**STAFF RECOMMENDATION**  
**918 Acklen Avenue**  
**October 21, 2020**

**Application:** New Construction—Infill and Outbuilding  
**District:** Waverly-Belmont Neighborhood Conservation Zoning Overlay  
**Council District:** 07  
**Base Zoning:** R8  
**Map and Parcel Number:** 10509048100  
**Applicant:** Andrew Heideman, Four Square Design Studio  
**Project Lead:** Melissa Baldock, melissa.baldock@nashville.gov

**PROPOSED SITE PLAN**  
SCALE: 1" = 40'-0"

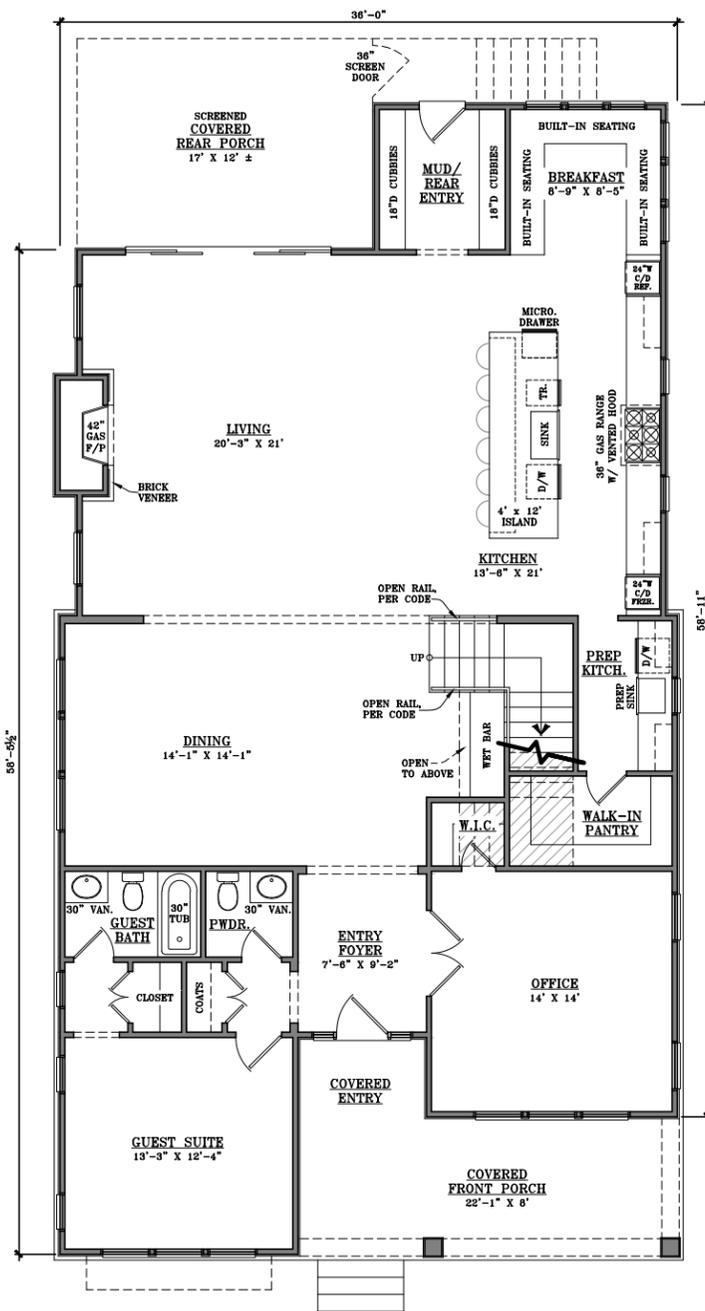
Setback & Rhythm of Spacing: The applicant intends for the infill to have a setback of approximately twenty-five feet (26’), which matches the front setback of the main wall of the infill approved at 916 Acklen in September 2020 and is similar to the front setback of the historic house at 922 Acklen Avenue.

The infill is at least five feet (5’) from the side property lines, and one hundred and twenty-seven feet (127’) from the rear property line. There are approximately ninety-two feet (92’) in between the rear of the house and outbuilding.

Staff finds that the infill’s proposed setbacks and rhythm of spacing to meet Section III.C. of the design guidelines.

Appurtenances & Utilities: No changes to the site’s appurtenances were indicated on the drawings. The location of the HVAC and other utilities was also not noted. Staff asks that the HVAC be located on the rear façade, or on a side façade beyond the midpoint of the house.

1. The finished floor height be consistent with the finished floor heights of the adjacent historic houses, to be verified by MHZC staff in the field;
2. Staff approve the masonry samples, all windows and doors, the roof shingle color and texture, and the driveway material prior to purchase and installation; and
3. The HVAC be located behind the house or on either side, beyond the mid-point of the house.

**PROPOSED ELEVATIONS -  
MAIN HOUSE**

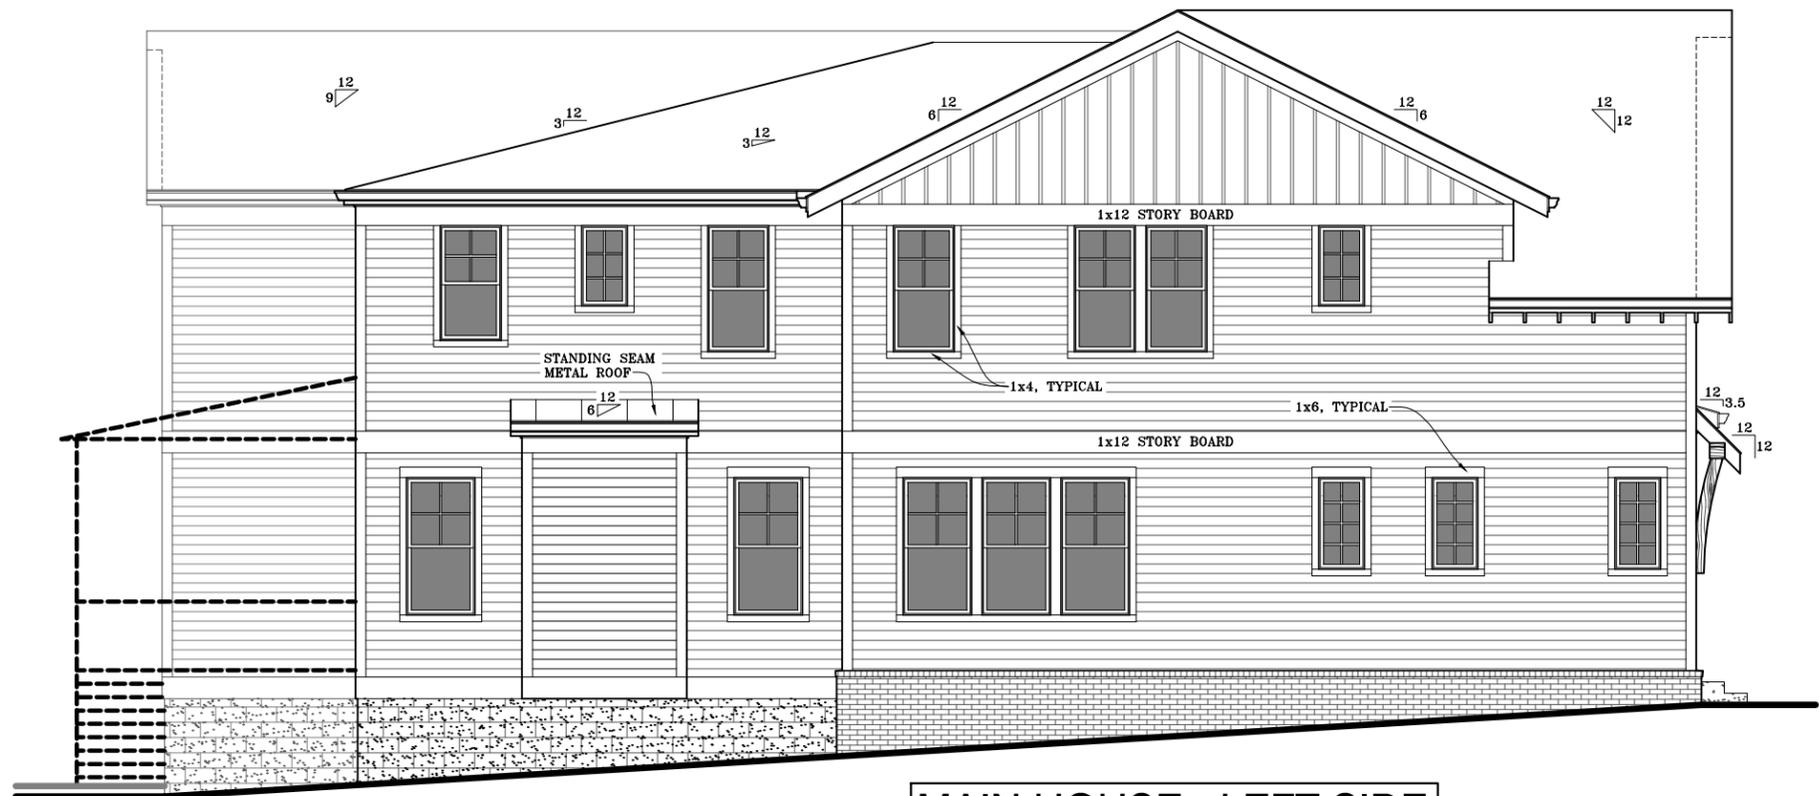
There is a noticeable cross-slope and front-to-back slope on these lots. The foundation is drawn so that it is as low as possible on the house’s left side, but it will be taller on the right side. For lots like this, the foundation and finished floor inspections are critical to ensure that the foundation and finish floor heights match the historic context.

The house is thirty-six feet (36’8”) wide, which meets the historic context. Its depth will be approximately seventy-four feet (74’), which staff finds to meet the historic context, particularly since the lot is two hundred and twenty-five (225 ft.) deep. The height of the house will be twenty-eight feet, ten inches (28’10”) above the foundation line, which varies due to slope. Staff finds that the overall height and scale are similar to other historic houses in the immediate vicinity and to meet the design guidelines.

Roof form: The house's primary roof form is a cross gable with a 12/12 pitch. Other secondary gables are 6/12 and 9/12, and the rear has a 3/12 hipped roof form. The front porch roof will be a 3.5/12 shed. Staff finds that these roof forms are similar to other roof forms in the immediate vicinity.

Proportion and Rhythm of Openings: The windows on the proposed infill are all generally twice as tall as they are wide, thereby meeting the historic proportions of openings. There are no expanses of wall space without a window or door opening, Staff finds the infills’ proportion and rhythm of openings to meet Section III.G. of the design guidelines.

**PROPOSED ELEVATIONS -  
ACCESSORY GARAGE**

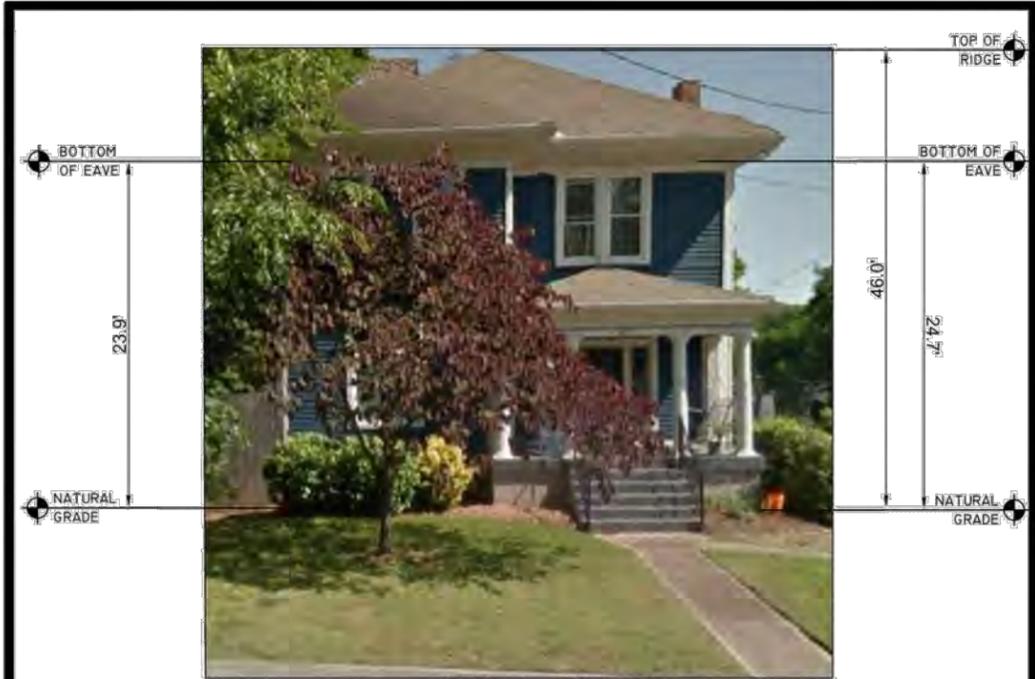
The outbuilding will have eave and ridge heights that vary from grade because of the extreme slope of the lot, but will still meet the maximum heights set forth in the design guidelines.

Staff finds that the proposed outbuilding meets Section III.H.1.c of the design guidelines for height and scale.

The roof form does not include any dormers. Staff finds that the outbuilding meets Section III.H.3 of the design guidelines for roof shape.

The known materials meet the design guidelines. With staff approval of the final selections of the roof color and details, windows, and doors, staff finds the materials to meet Section III.H.4 and 5. of the design guidelines.
